**SUMMARY OF CURRENT UNDERSTANDING OF
DRIFT DEGRADATION AND ITS EFFECTS ON
PERFORMANCE AT A POTENTIAL
YUCCA MOUNTAIN REPOSITORY**

**U.S. Nuclear Regulatory Commission
Contract NRC-02-02-012**

**Center for Nuclear Waste Regulatory Analyses
San Antonio, Texas**

**August 2006
Revised January 2007**

Figure 4-2. Comparison of FracMan Synthetic Fracture Populations Based on Input From (a) DOE (Bechtel SAIC Company, LLC, 2004b, Figure 6-18, p. 6-34) and (b) CNWRA (Smart, et al., 2006)

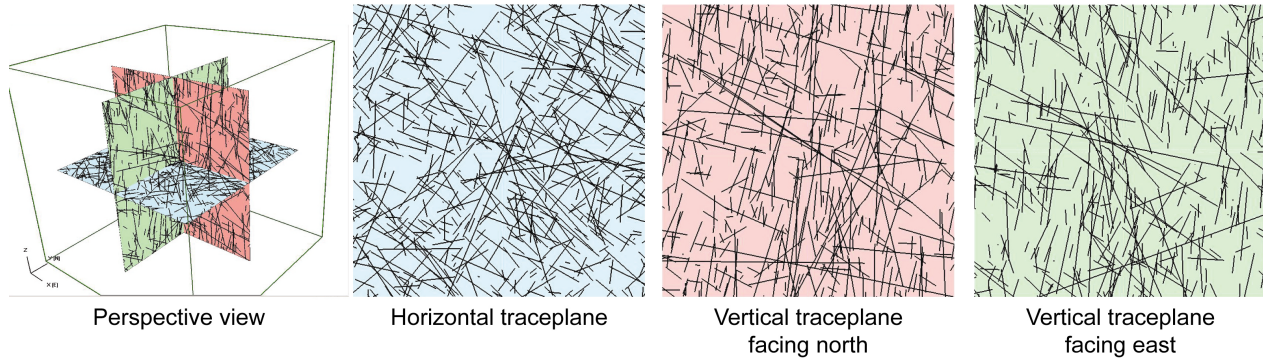
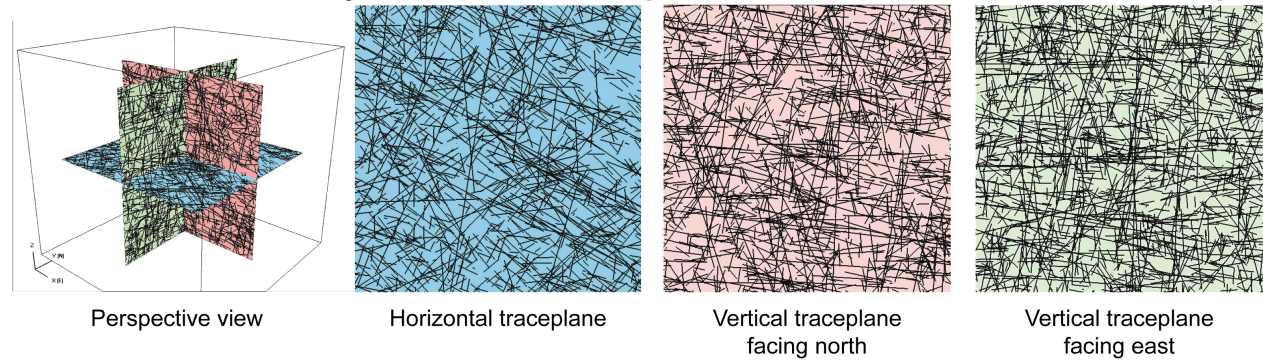
Staff have previously expressed concern (NRC, 2004; Virgilio, 2004) with the DOE representation of the Yucca Mountain fracture data in the FracMan analysis and indicated that a quantitative comparison of the DOE-generated FracMan synthetic fracture populations against the fracture data would be prudent. While the orientations of steeply dipping fractures in the synthetic population are similar to the natural fracture data, the shallowly dipping fracture set is underrepresented in the DOE synthetic population (Smart, et al., 2006). The DOE synthetic population also contains a concentration of moderately northeast-dipping fractures (Bechtel SAIC Company, LLC, 2004b, Figure 6-19, p. 6-38) that are not observed in the natural fracture population (Smart, et al., 2006, Figure 3-7, p. 3-17).

A synthesis of subsurface fracture data collected at Yucca Mountain demonstrates that the median spacing for low-angle fractures in the nonlithophysal rocks is less than the spacing for such fractures used in the DOE drift degradation analyses (Smart, et al., 2006, Table 5-1, p. 5-2). For the Topopah Spring Tuff middle nonlithophysal zone in particular, the spacing for low-angle fractures calculated from DOE data (Smart, et al., 2006, p. 5-2) is nearly five times smaller than the spacing used for the same fractures in the DOE analysis (Bechtel SAIC Company LLC, 2004b). To better understand the potential effect of this spacing difference, CNWRA staff performed independent simulations using FracMan (Golder Associates, Inc., 2002, 1998). Results suggest that the FracMan simulations based on the spacing calculated by Smart, et al. (2006) could lead to a greater number of low-angle fractures (Figure 4-2), which is readily observed on the vertical surfaces. As Table 4-1 shows, the fracture intensity calculated from the independent FracMan simulation by CNWRA staff matches the Yucca Mountain data more closely than the fracture intensity from a FracMan simulation based on the DOE inputs. The CNWRA staff analyses suggest that the total number of rock blocks that fall could be greater in the 3DEC simulations if a larger number of low-angle fractures was included. While the block size distribution was not specifically assessed by CNWRA analyses, the proportion of large blocks is expected to be smaller.

rock-mass model with fewer kinematically removable blocks than may be realistic for the nonlithophysal rock at Yucca Mountain. The DOE analysis would have resulted in greater rockfall volumes and larger changes in emplacement-drift geometry if a more accurate representation of fracture connectivity had been used.
